901 Harrison

Design Review Board

MACFARLANE PARTNERS & ANKROM MOISAN ARCHITECTS, INC.
DPD #3016723 / **NOVEMBER 05, 2014**

LOBBY ENTRANCE AT 9TH AVENUE

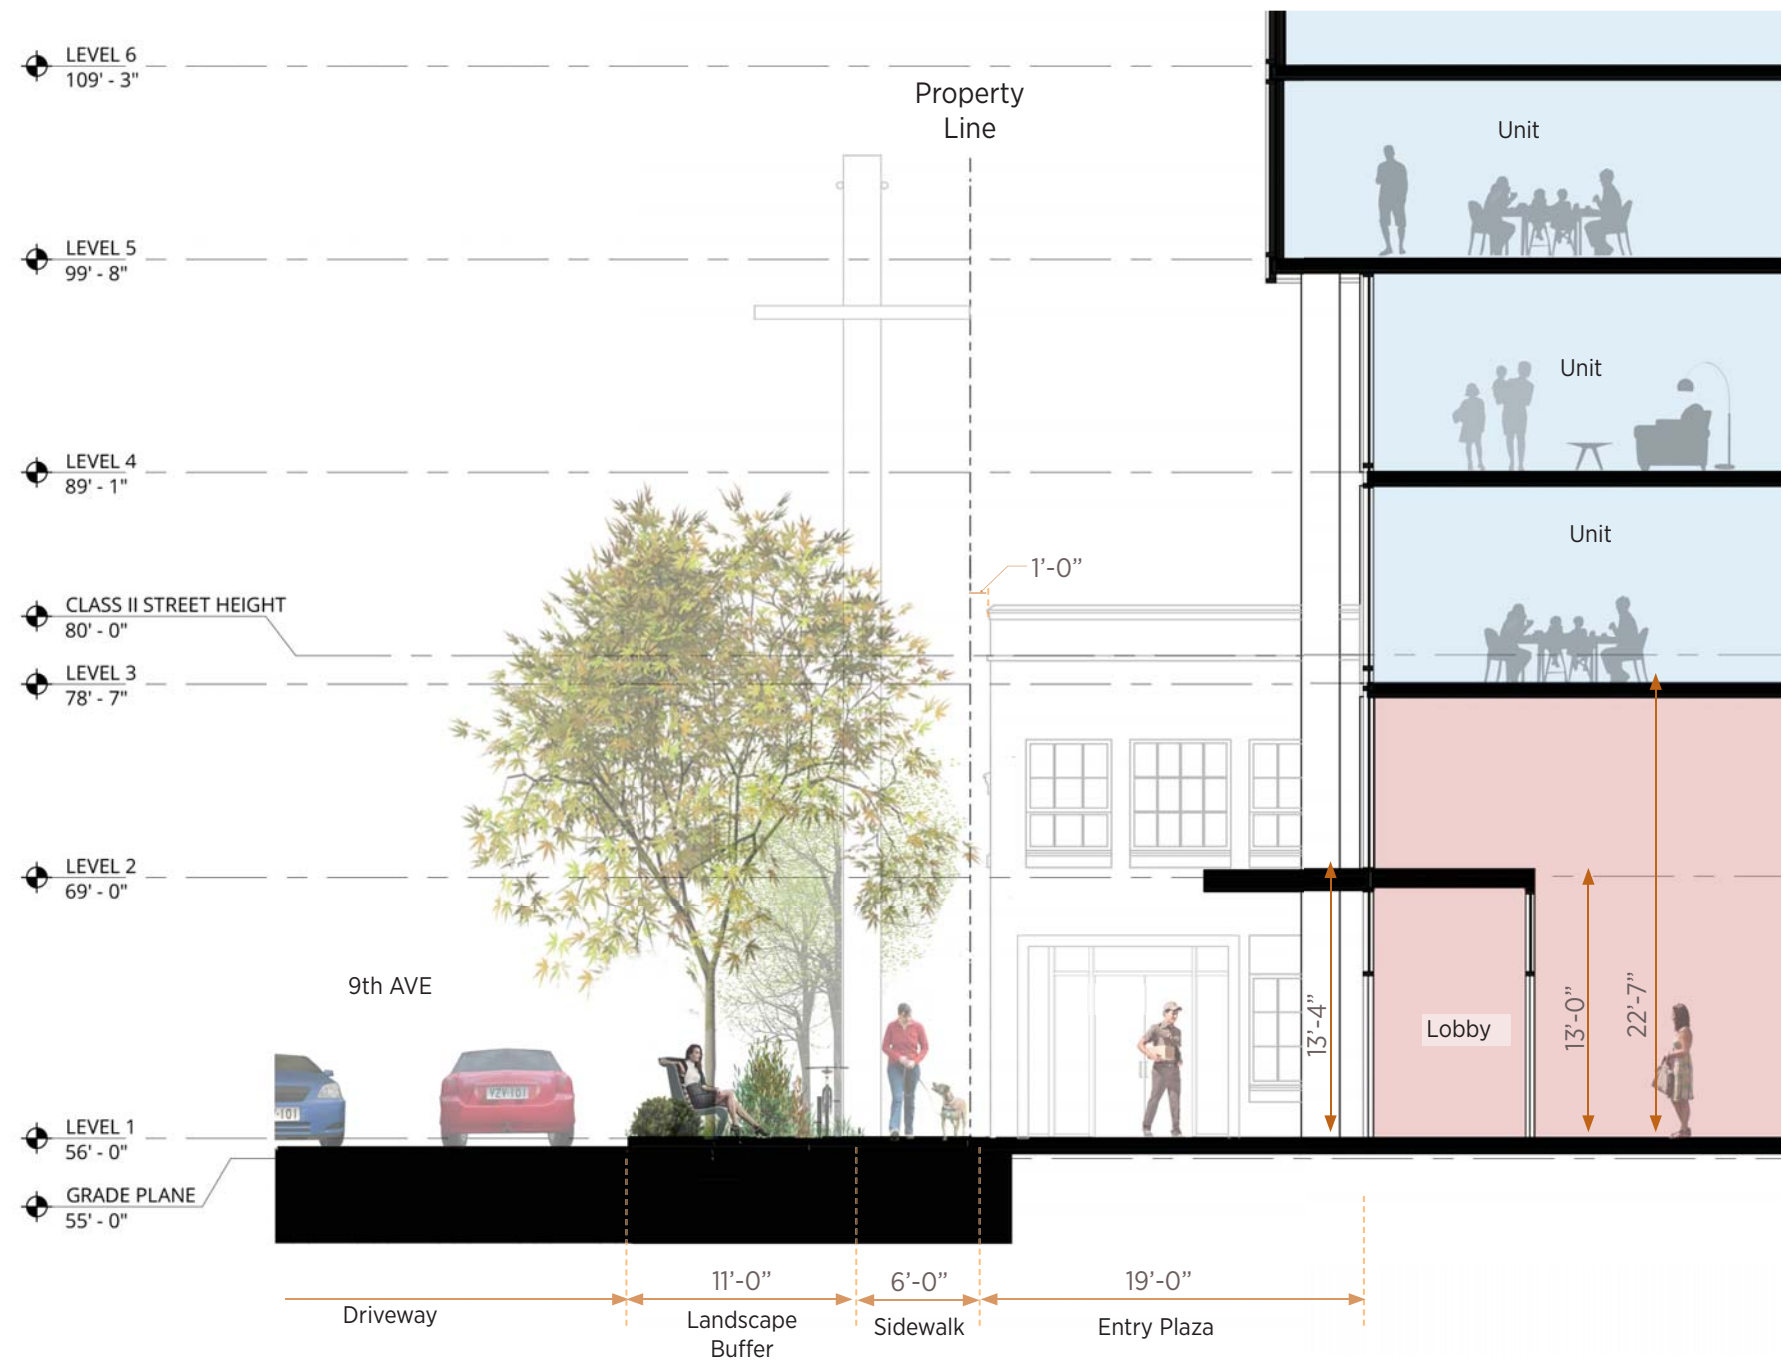
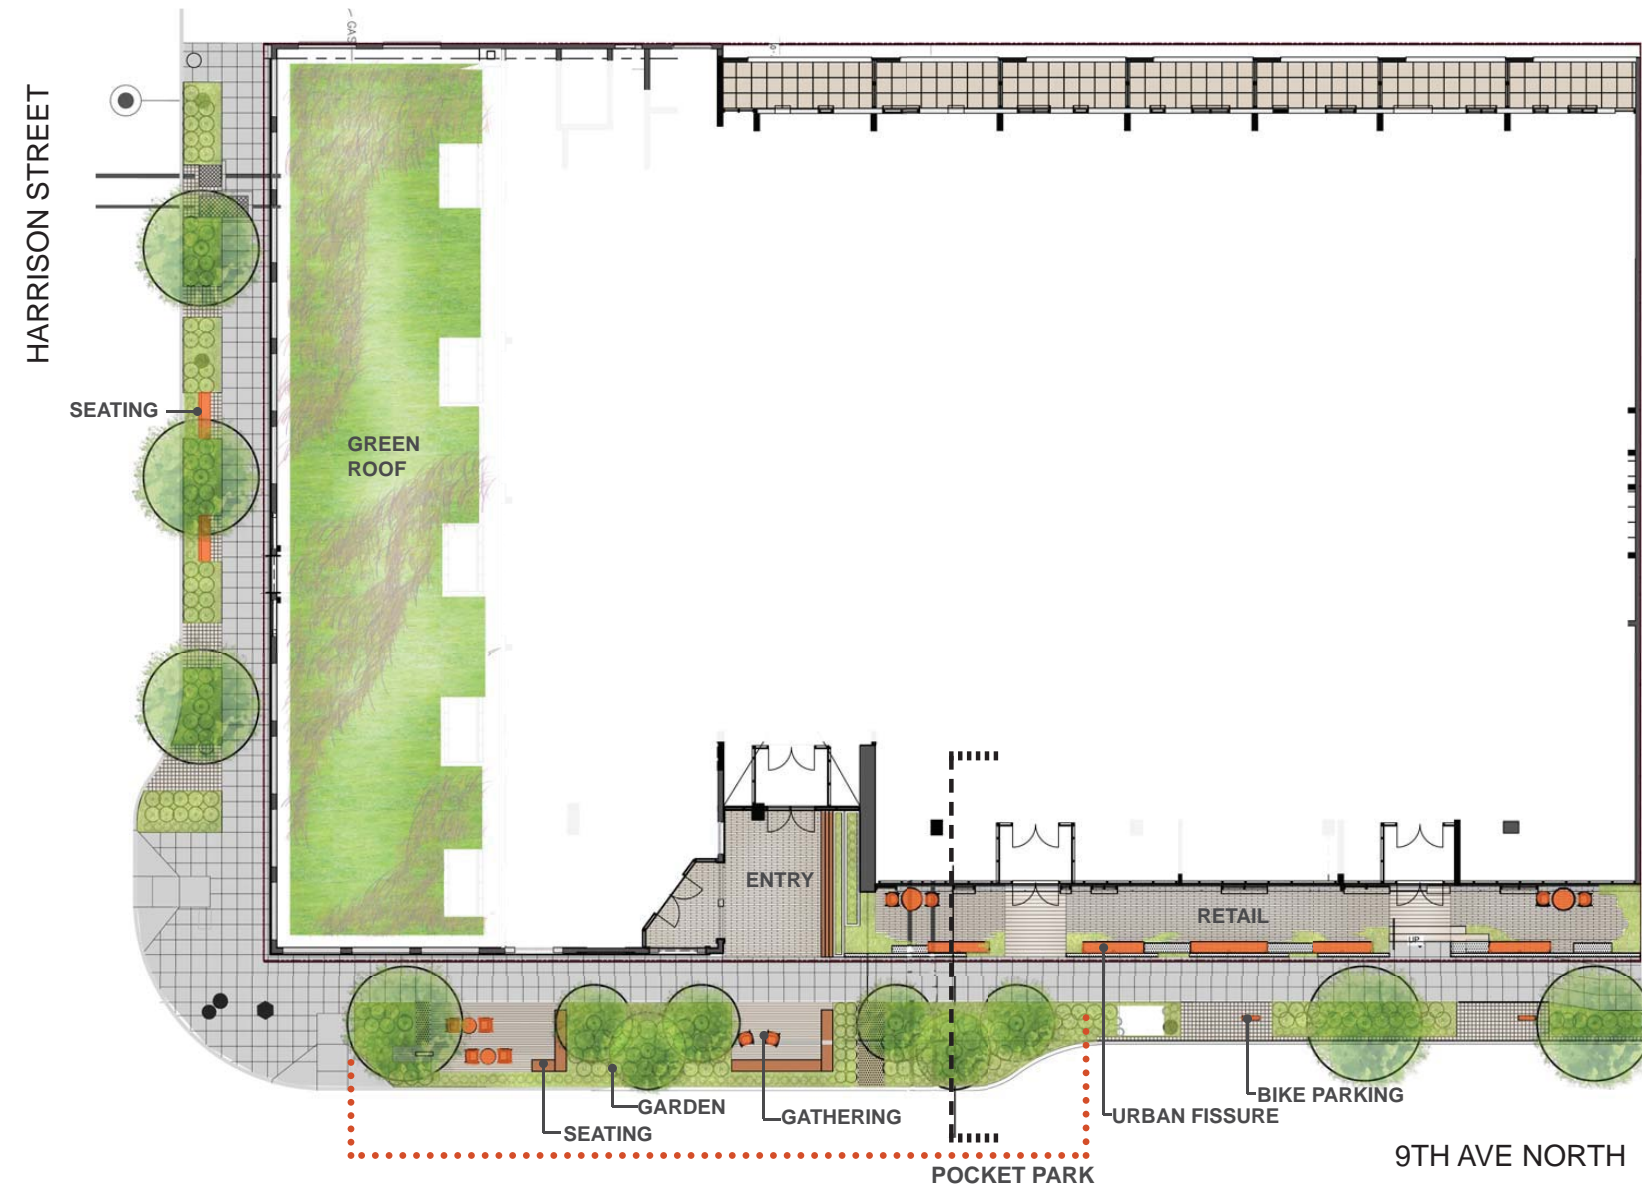
- 2a** “...strongly consider placing retail on 9th Ave N,” (CS2.B.2, PL2.I)
- 2b** “.....respond to the developing context at the intersection and the Heart Location designation of Harrison St....” (CS2.A.2, CS2.II.ii, DC2.A)
- 2c** “The Board supported the proposed curb bulb and street furniture to enhance the pedestrian experience.” (PL1.III)
- 2d** “The Board supported varying the design of the overhead weather protection at the street frontage...” (PL2.C)
- 2e** “The Board also supported the conceptual sketches indicating the design intent for the street level entries, street facing facades, landscaping, and hardscape.” (PL3.A.1 and 4)
- 2f** “The 9th Ave N. curb bulb and street level treatment should be designed to respond to the intended bicycle route along 9th Ave N. and the neighborhood streetscape plan for 9th Ave N.”

- Expanded curb bulb as **pocket park** engaging the public sidewalk and lobby/retail spaces
- Trees clustered to create a **garden** setting
- Fixed elements provide artistic **seating** opportunities

- Paving accents create area rugs for **gathering** spaces and separation of uses
- **Bike parking** distributed along length street relating to retail spaces

- Sidewalk and retail space along 9th separated by an **urban fissure** concept – accessible in places and visible along length: linear curbs, narrow planting slots, seat walls, and lean rails

3. Alley

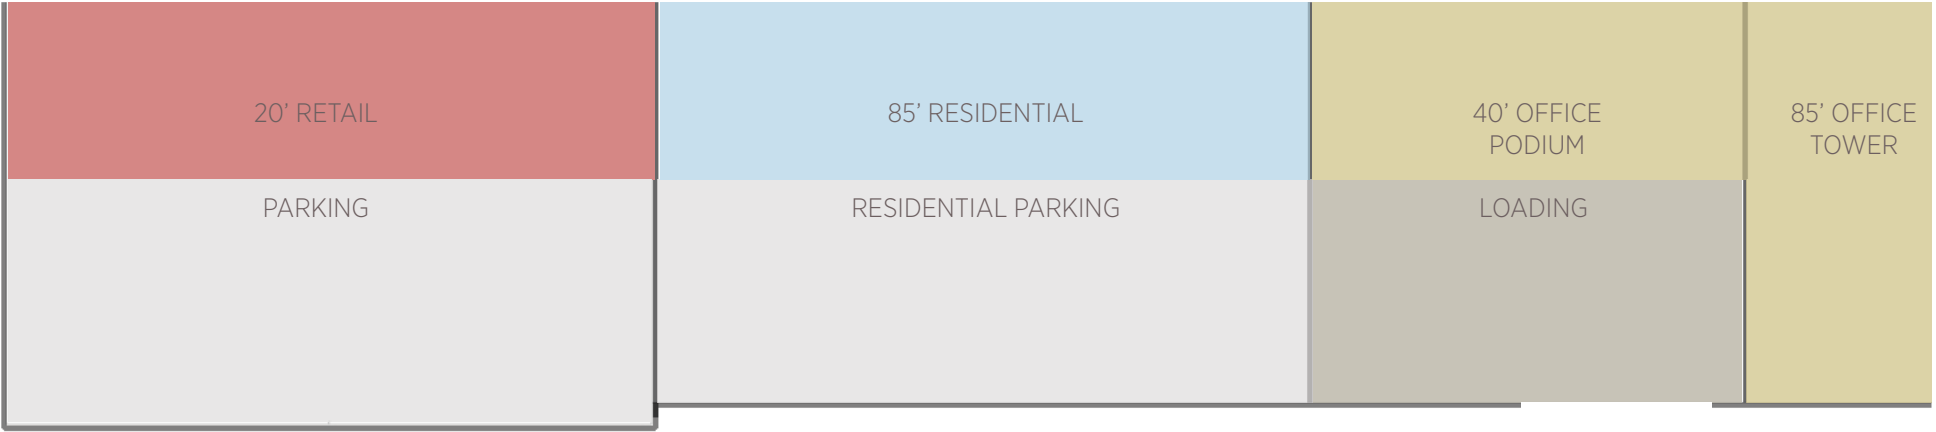
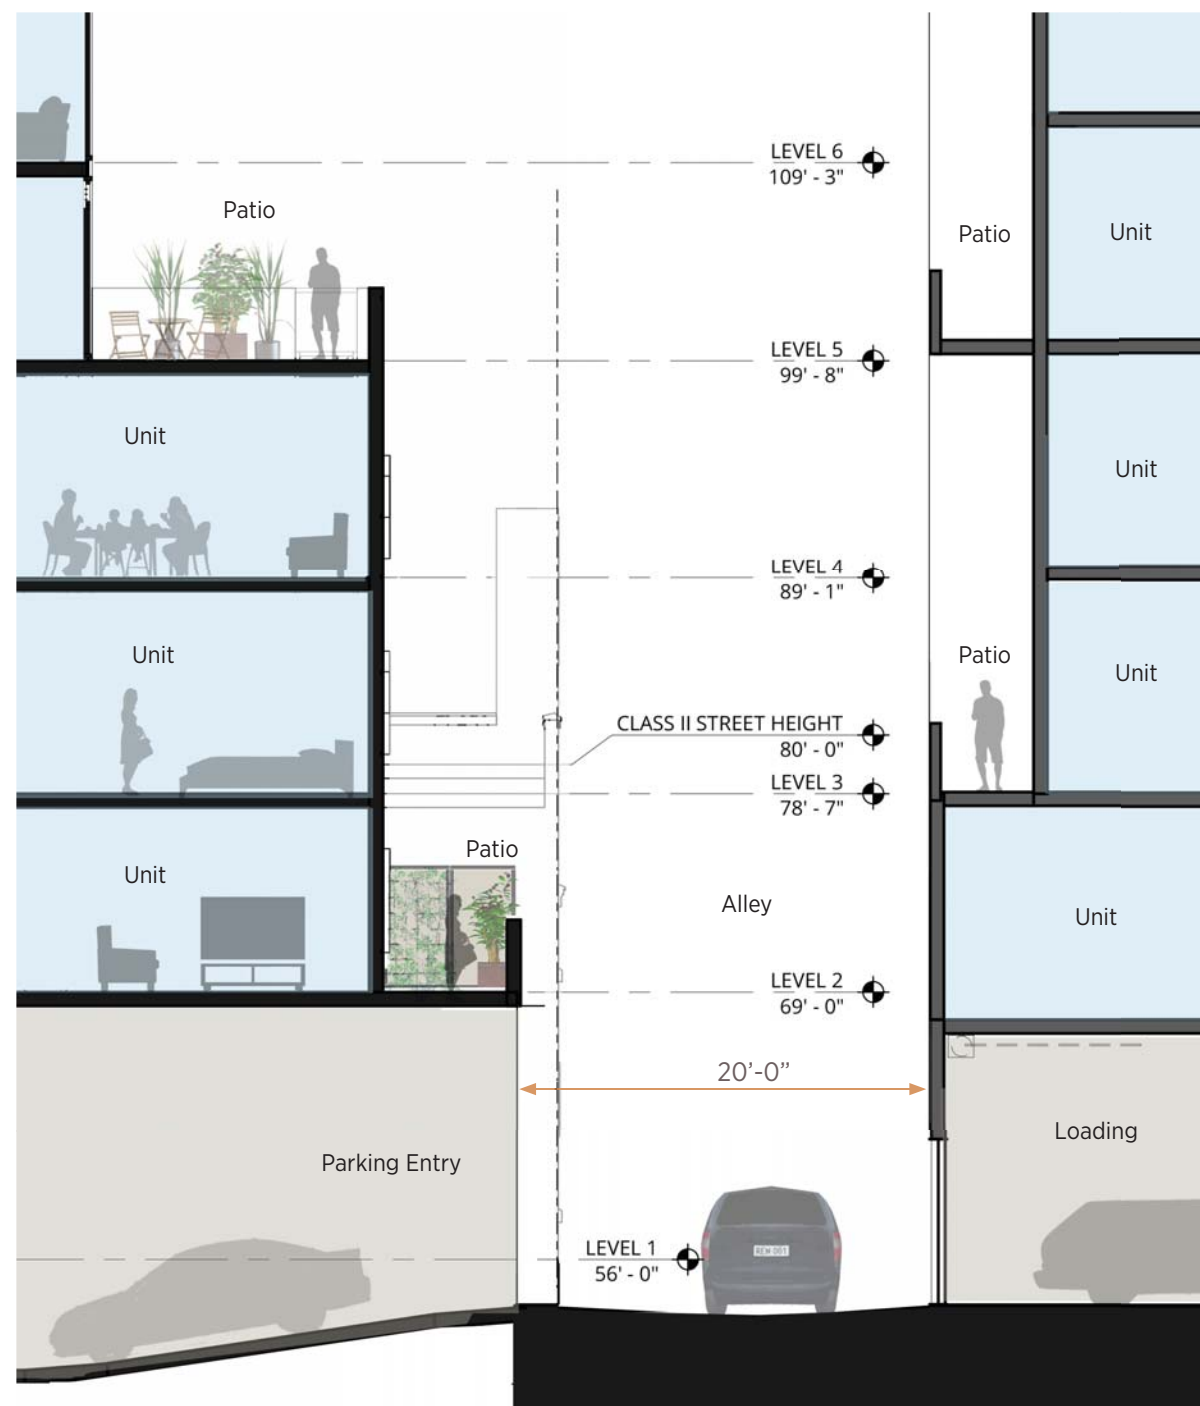
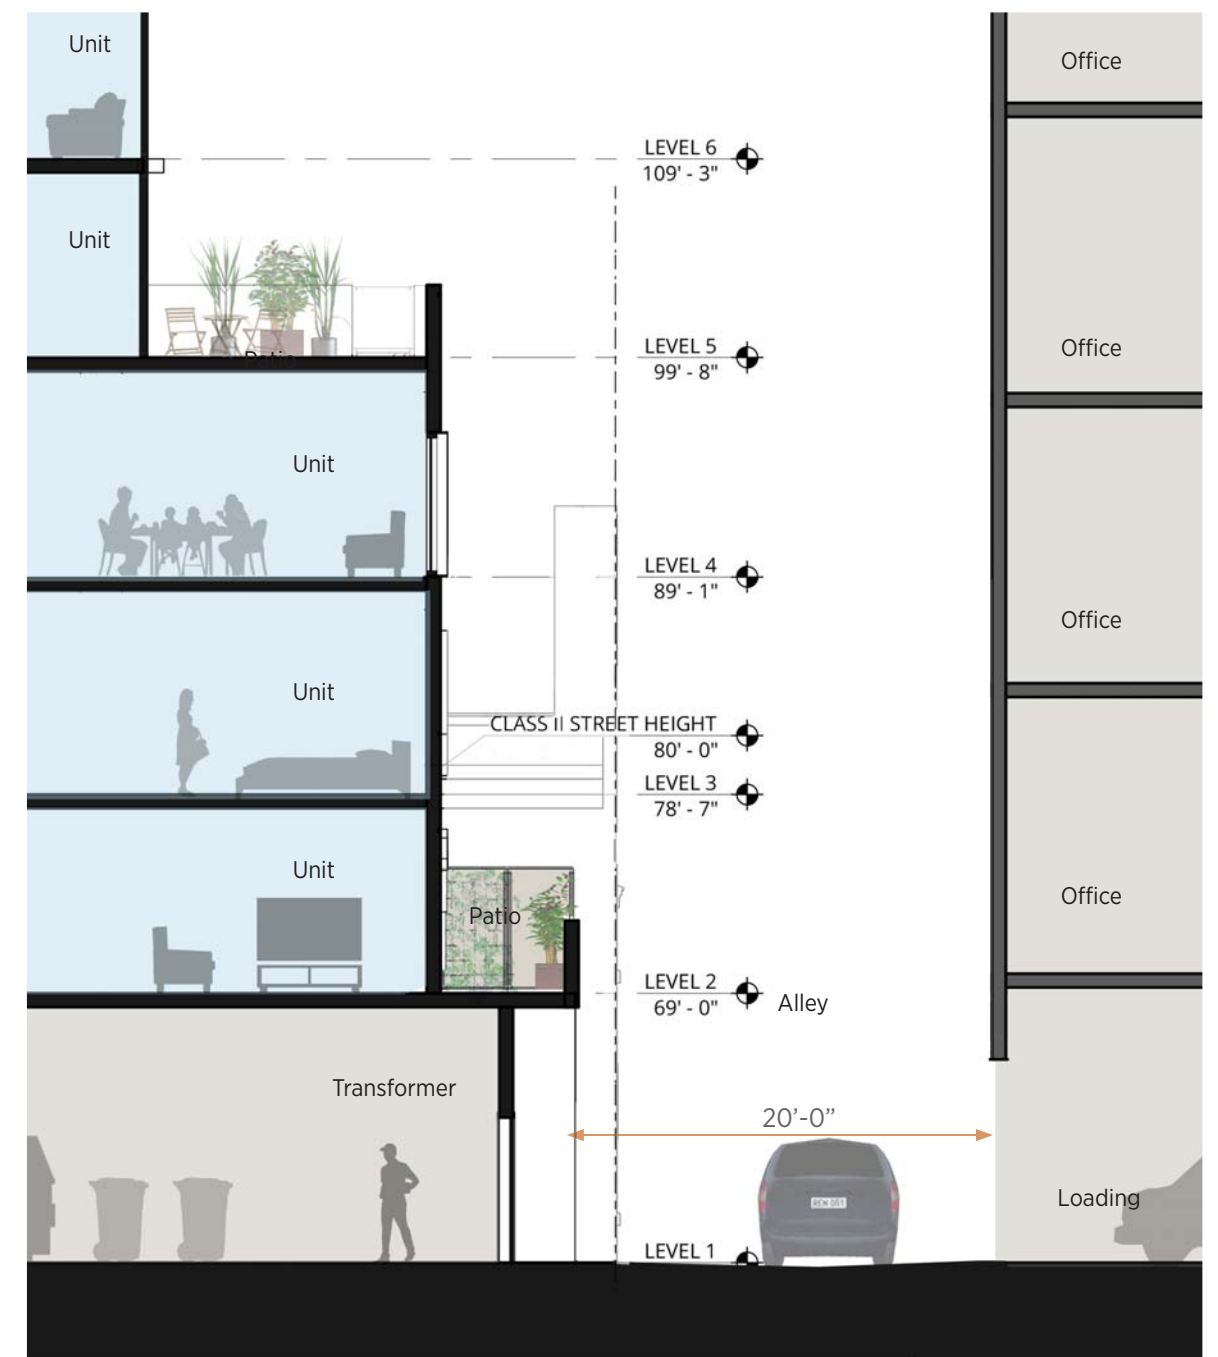
- 3a** “Lighting should enhance pedestrian safety, especially at the alley.” (PL1.I.iii)
- 3b** “The Board noted that since the north end of the alley will include pedestrian activity, the location of services near the southeast corner of the site is an appropriate response to the context and the proposed design.” (DC1.C.4)
- 3c** “The alley façade should be designed to be consistent with the other three facades of the building, given the pedestrian activity, visibility of the façade, and the proposed residential use across the alley.” (DC2.B.1)
